Technical Service BULLETIN

FRONT SEAT TRACK SQUEAK

'03 – '06 4Runner

NV005-06

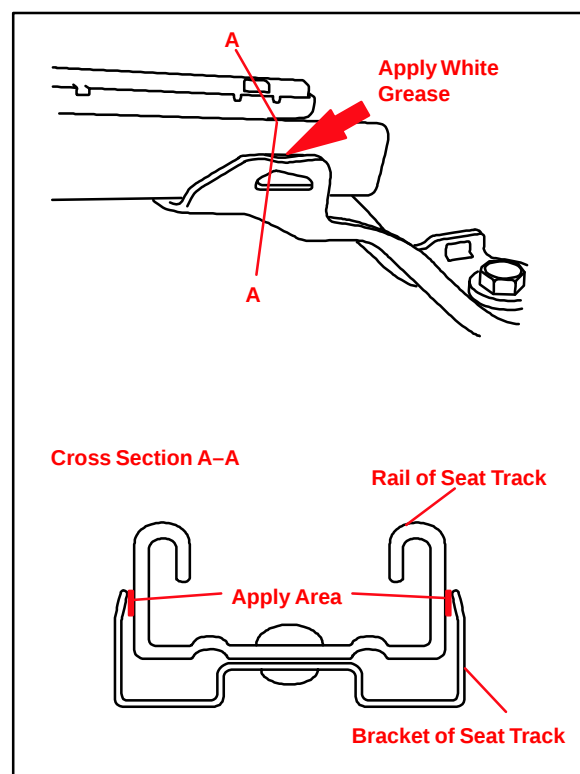
2. Apply aerosol spray type white grease between the seat track rail and bracket as shown.

- When applying lubricant to the seat track, cover the carpet with paper or sheet plastic to protect from overspray.
- There are a total of 8 apply areas — 2 at the front and 2 at the rear of each of the two seat tracks.
